Access Compliance Report

Public Rights-of-Way

(Curb Ramps)

Intersection ID: 3205	Main Street: LANSHIRE_CT	Cross Street: SHELLY_PINES_DR	Location: NW
ADA ID: E450ADFC7962	Ramp Type: Perp	Initial Pass/Fail: Fail	Overall Compliance: No
		Severity Score: 25

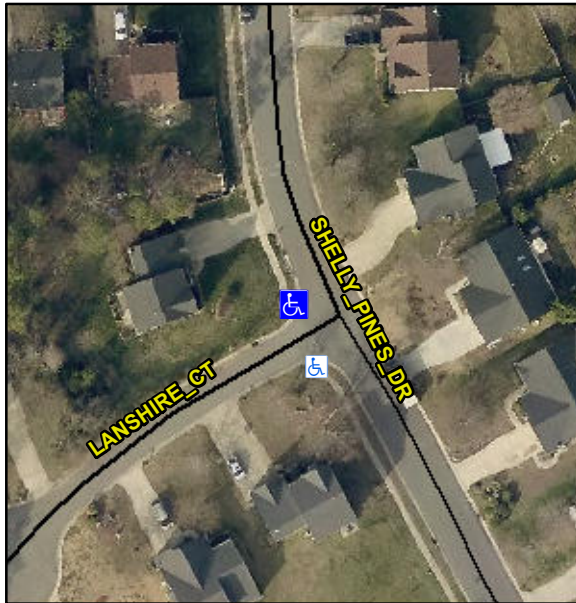
Not Found, R304.5.3

Compliance	Description	Data	Compliance	Description	Data
N/A	Ramp Length (in)	46.0	Yes	Ramp Slope (%)	8.3
Yes	Ramp Width (in)	60.0	No	Ramp XSlope (%)	8.5
N/A	Flare Type LT	N/A	N/A	Flare Type RT	N/A
N/A	Flare Slope LT (%)	N/A	N/A	Flare Slope RT (%)	N/A
N/A	Flare Traversable LT?	N/A	N/A	Flare Traversable RT?	N/A
N/A	Landing Length (in)	N/A	N/A	DWS Provided?	N/A
N/A	Landing Width (in)	N/A	N/A	DWS Contrast?	N/A
N/A	Landing Slope (%)	N/A	N/A	DWS Length (in)	N/A
N/A	Landing X Slope (%)	N/A	N/A	DWS Full Width?	N/A
N/A	Landing Curb? (Y/N)	N/A	N/A	DWS Offset (in)	N/A
N/A	Shared Landing?	N/A			
N/A	Gutter Ponding?	N/A	N/A	Gutter Slope (%)	N/A
N/A	Gutter Lip Ht (in)	N/A	N/A	Gutter X Slope (%)	N/A
N/A	Painted X Walk1?	No	N/A	Painted X Walk2?	N/A
	X Walk 1 Direction	To S		X Walk 2 Direction	N/A
N/A	X Walk 1 Width (in)	N/A	N/A	X Walk 2 Width (in)	N/A
	X Walk 1 Slope (%)	6.3		X Walk 2 Slope (%)	N/A
	X Walk 1 X Slope (%)	2.1		X Walk 2 X Slope (%)	N/A

Remove & Replace Entire Ramp.
